PROJECT NAME: SW 100TH STREET PUD - EAST

PROJECT NUMBER: 2021080035

APPLICATION: IMPROVEMENT PLAN #30222

REVIEW ITEM: Improvement Plan

Sheet No.
C006
of
C020

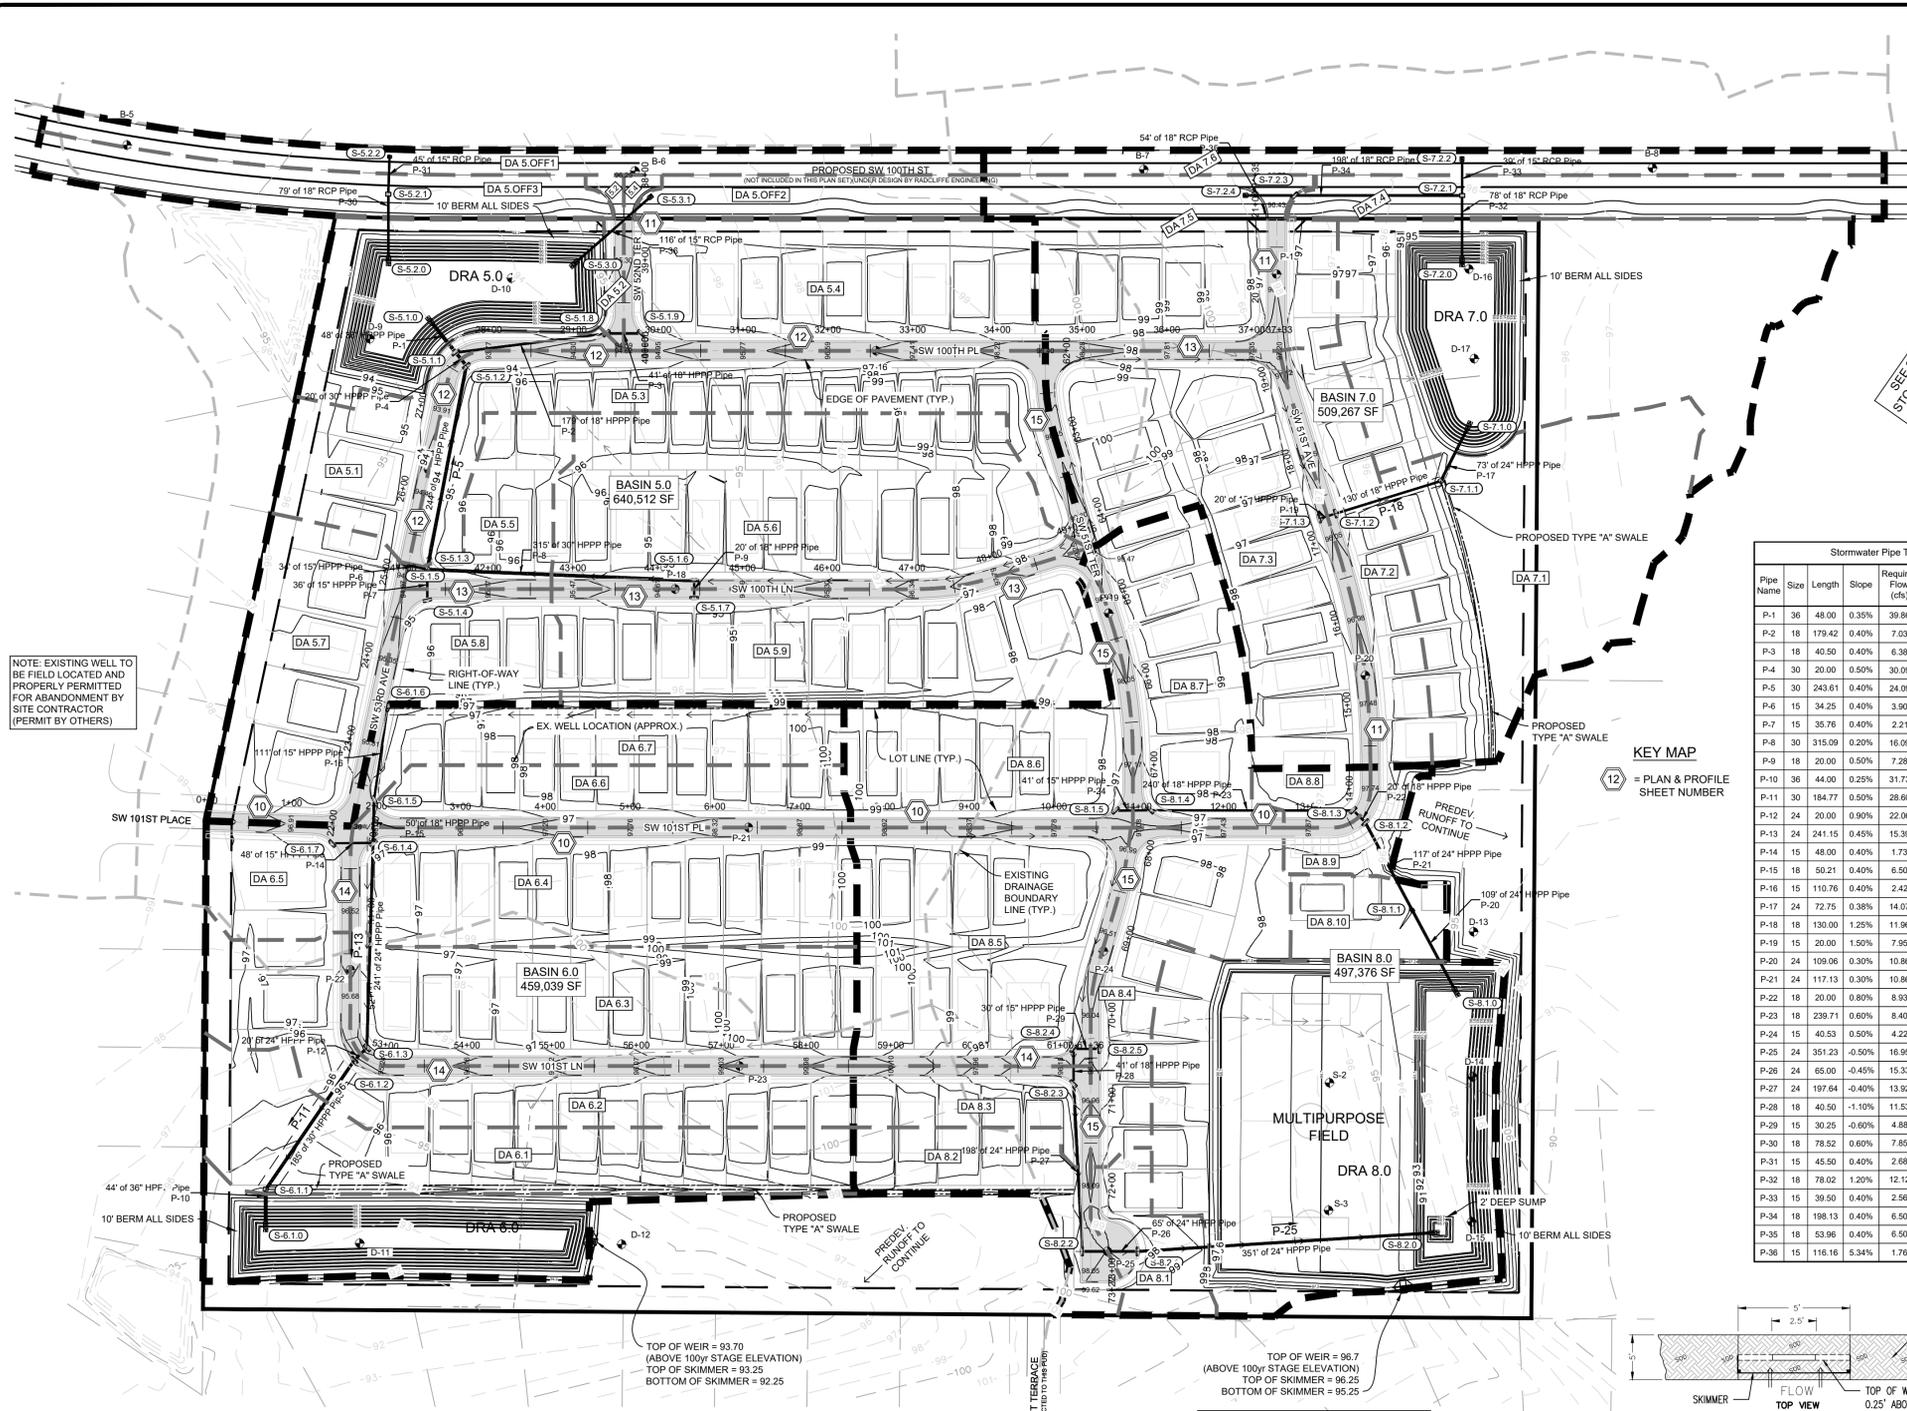
- 15 DEPARTMENT: ENGDRN - STORMWATER REVIEW
REVIEW ITEM: 6.13.8.B(3) - Lane Spread Calculations
STATUS OF REVIEW: NO
REMARKS: Please add to the Lane Spread calculations table the corresponding discharge capacity from the Flowmaster outputs so that the generated runoff flow can be readily be compared to the design capacity. The example provided in the text was helpful to understand the design intent. But it appears to be a check of one situation and not for all the appropriate locations.

Project Name: SW 101st St. PUD - East - Improvement Plans - Marion Co. FL
Sheet Name: Plan & Profile SW 101st Pl
Sheet No. C010 of C020

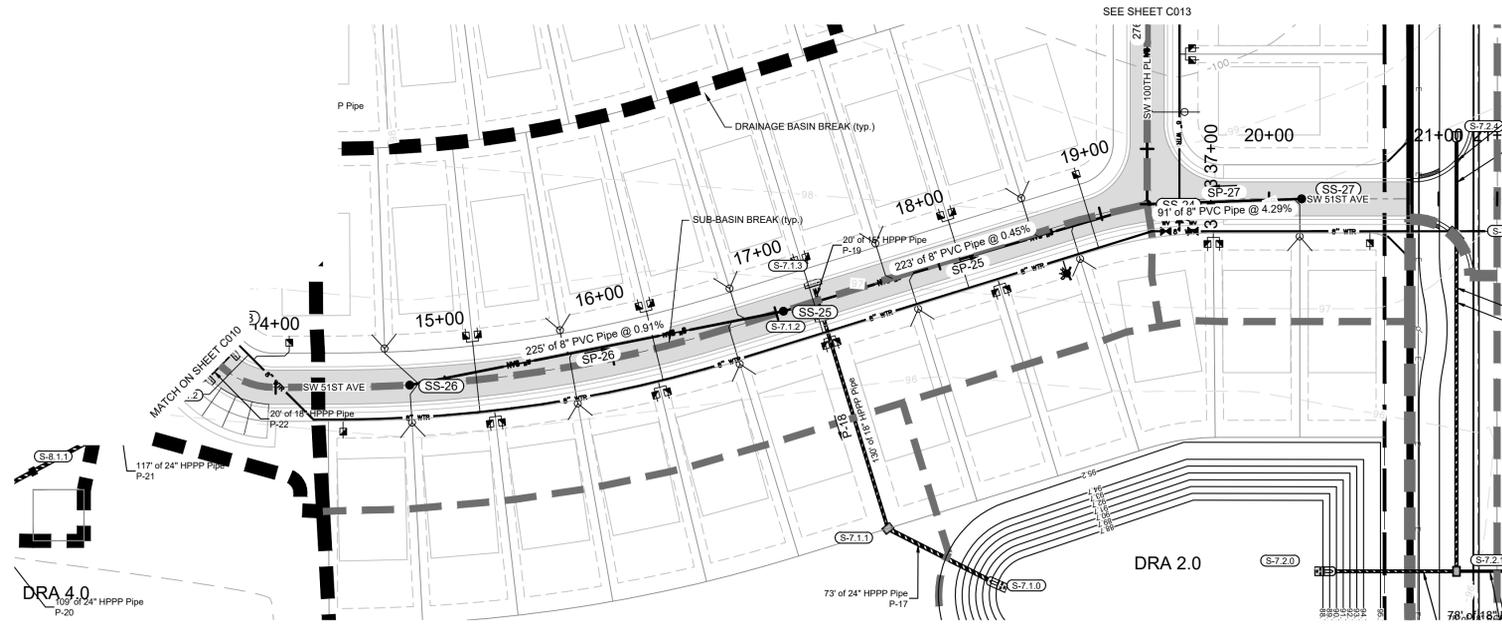
- 18 DEPARTMENT: 911 - 911 MANAGEMENT
REVIEW ITEM: 2.12.28 - Correct road names supplied
STATUS OF REVIEW: NO
REMARKS: Sheet C010 still has SW 101st PL labeled incorrectly as SW 100th LN in 2 places.

Sheet No.
C013
of
C020

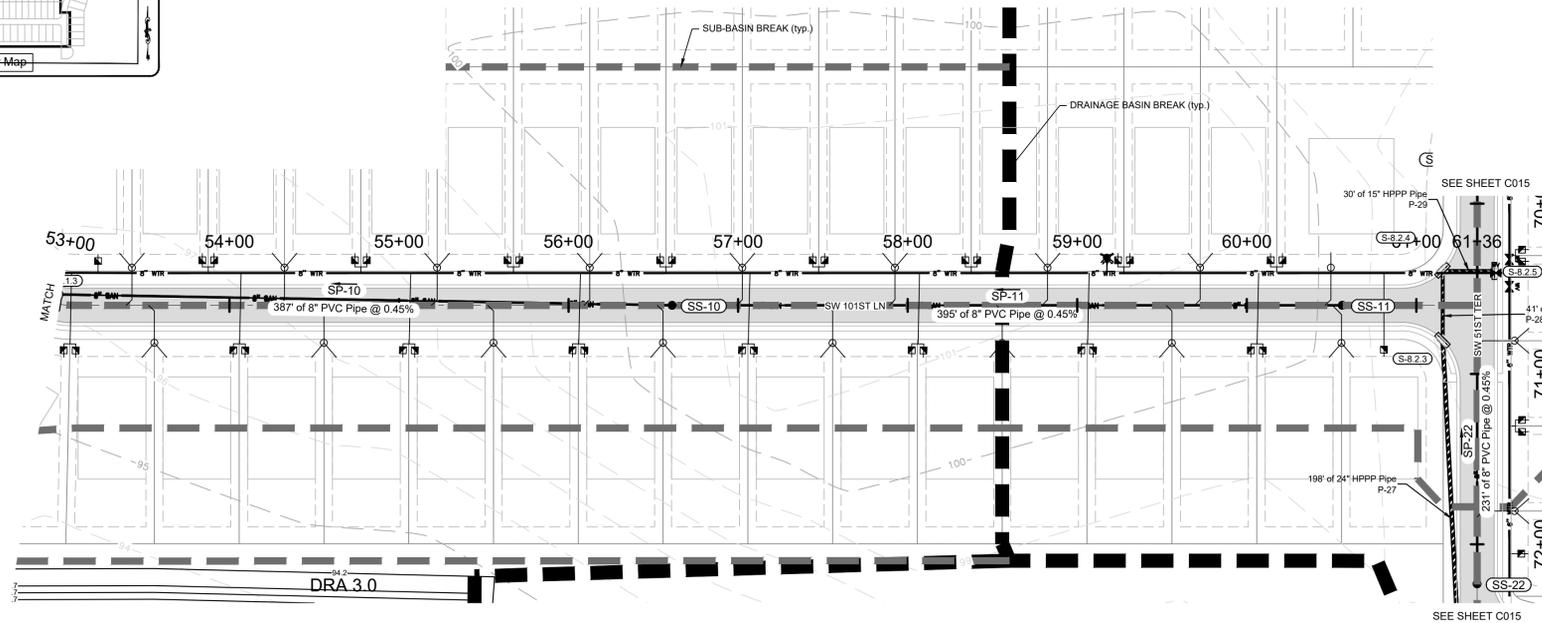
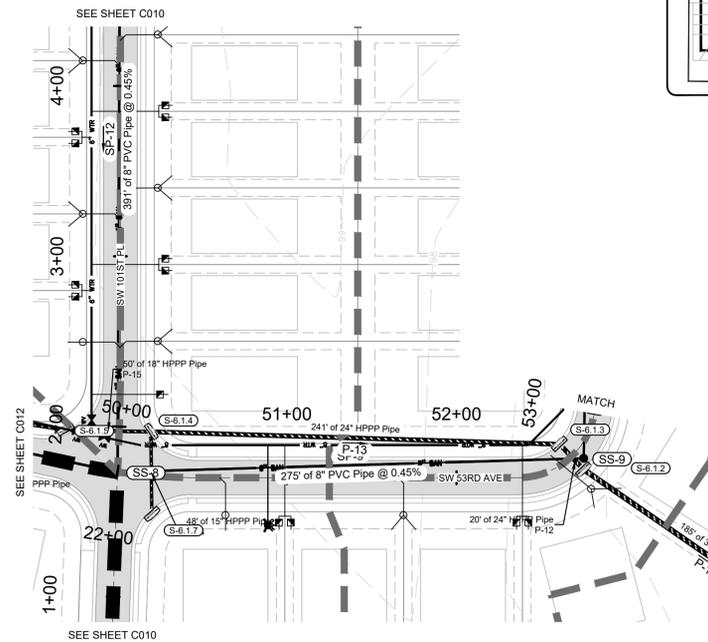
- 17 DEPARTMENT: UTIL - MARION COUNTY UTILITIES
REVIEW ITEM: Additional Utilities comments
STATUS OF REVIEW: NO
REMARKS: See changemarks in ePlans re: SS & MH on sheets C011 & C013

MASTER LANDSCAPE PLAN
 SW 100th STREET PUD - EAST
 MARION COUNTY FLORIDA

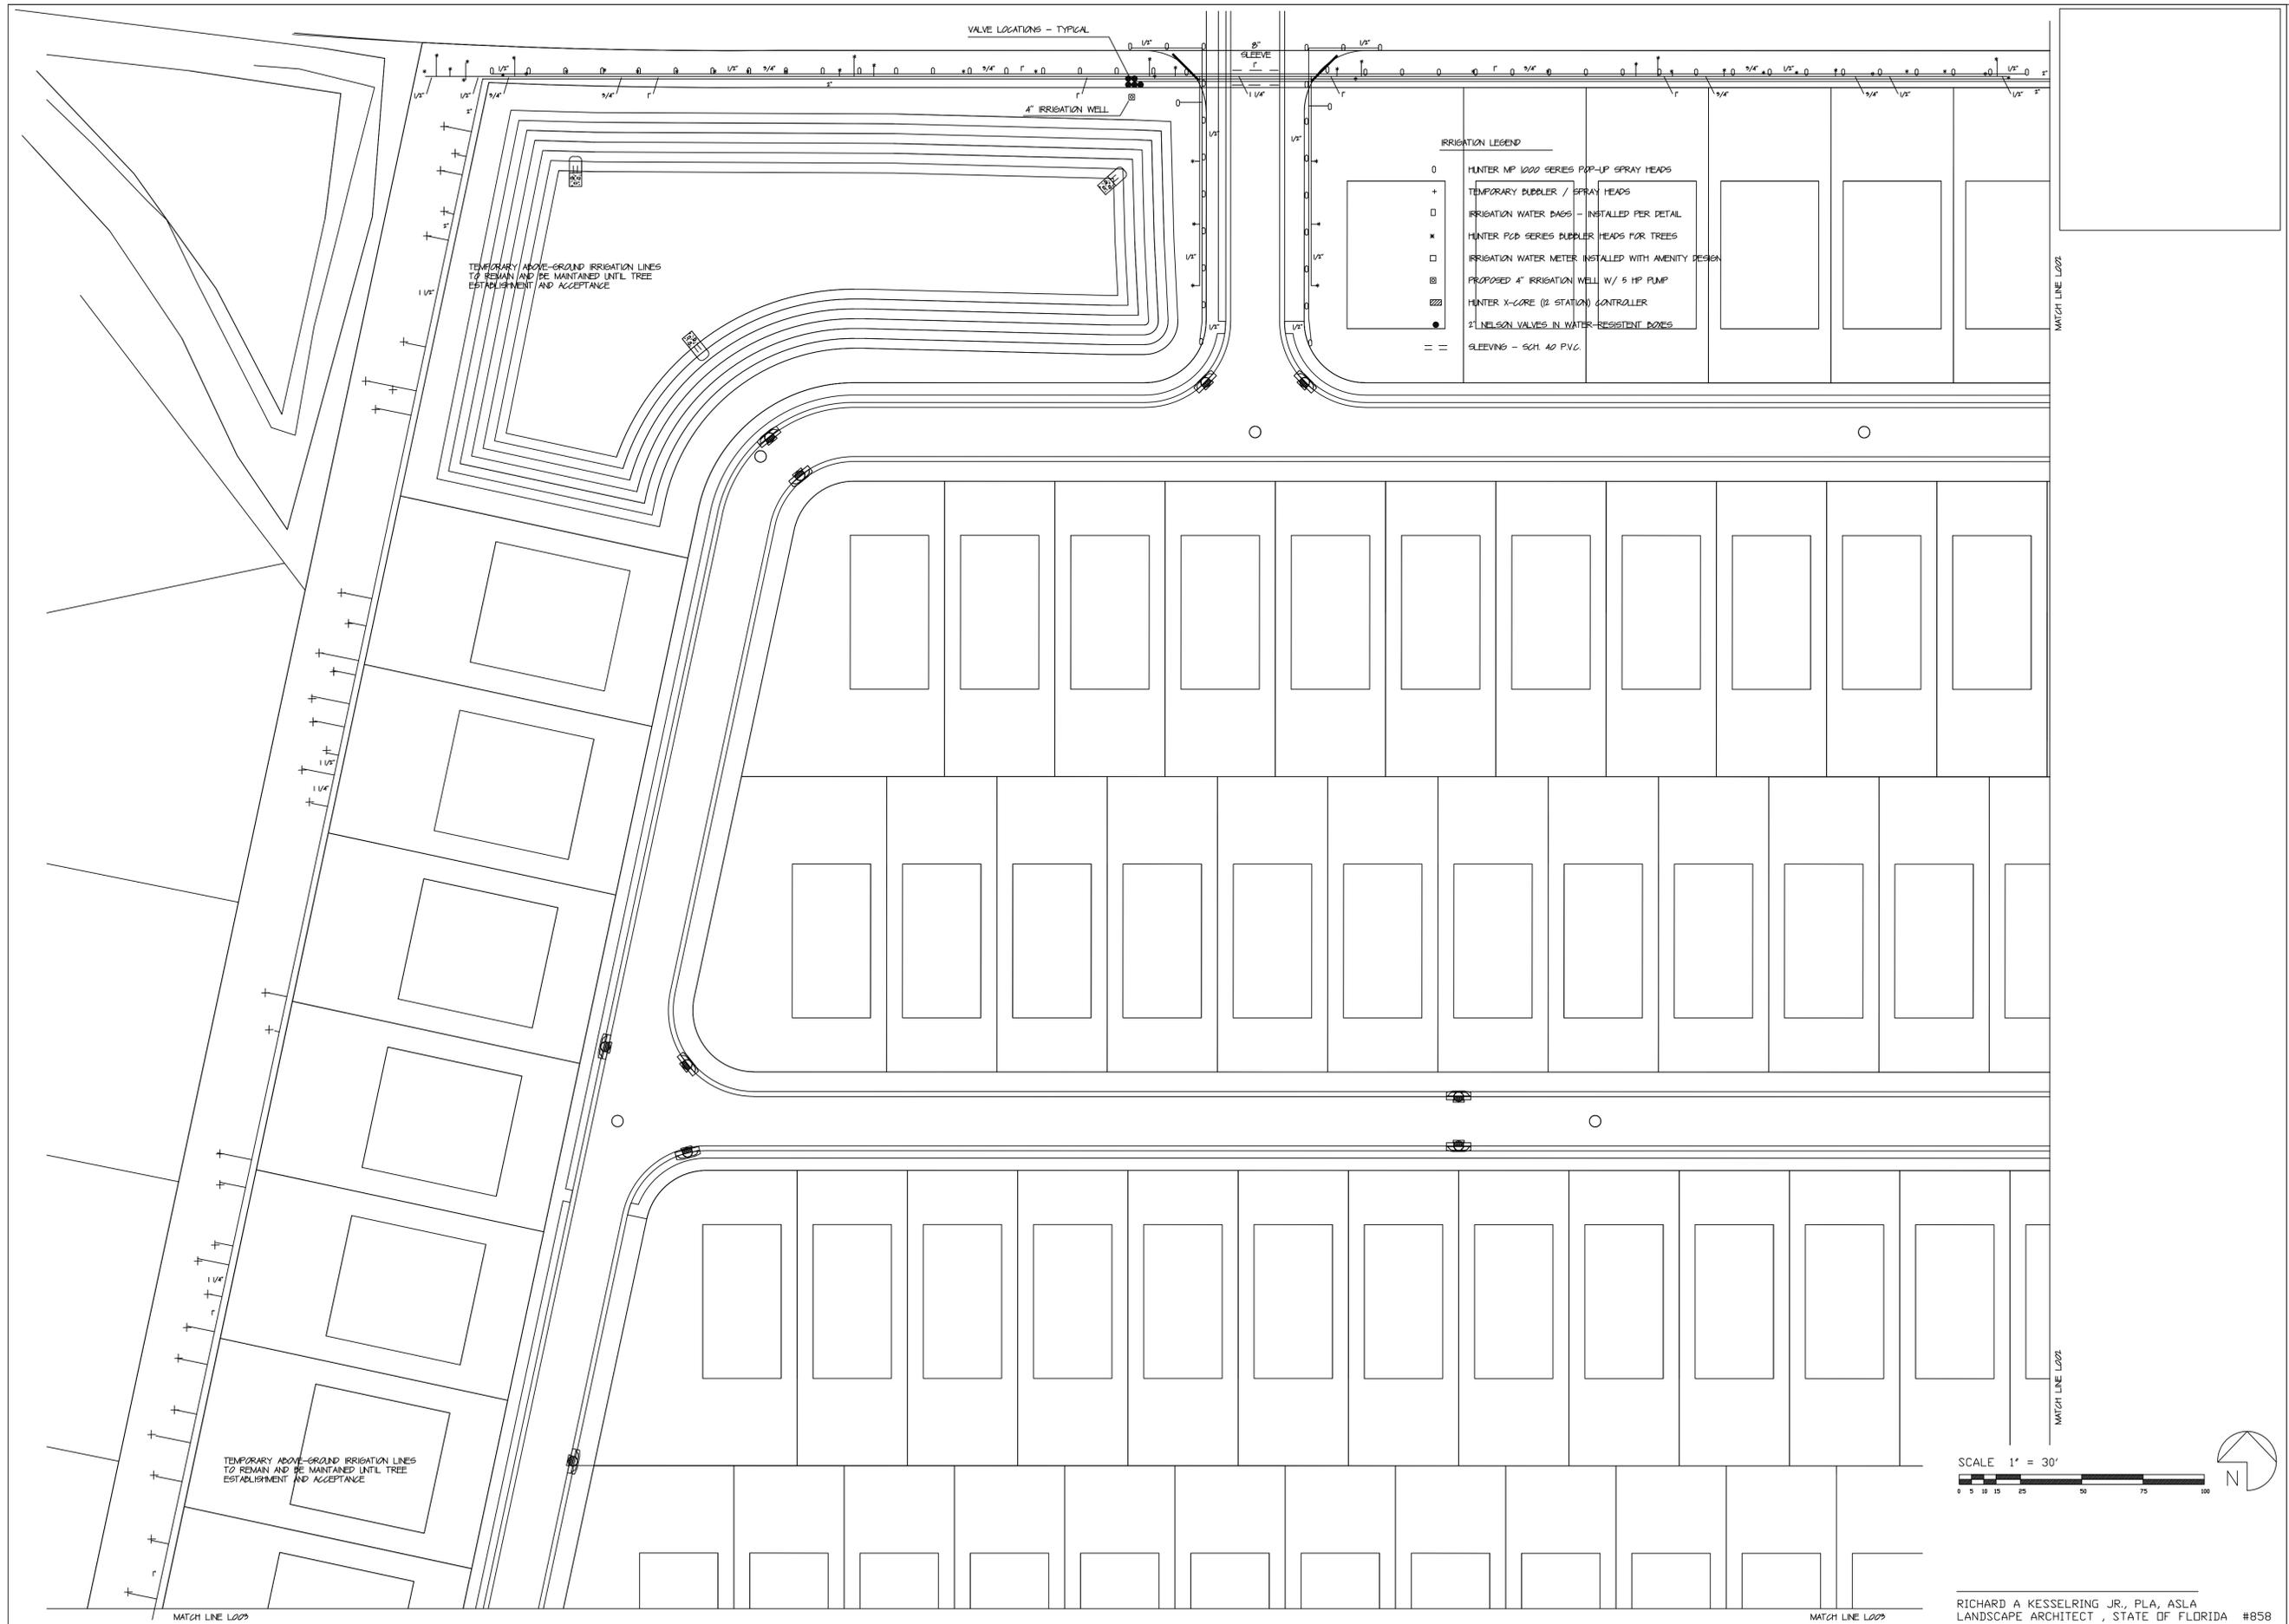
- 22 DEPARTMENT: LSCAPE - LANDSCAPE DESIGN AND IRRIGATION
REVIEW ITEM: 6.7.8 - Protected tree replacement requirements
STATUS OF REVIEW: NO
REMARKS: Please provide clearer tree replacement calculations. Are trees to remain in the conservation area? if so, should be shown on Landscape Plan
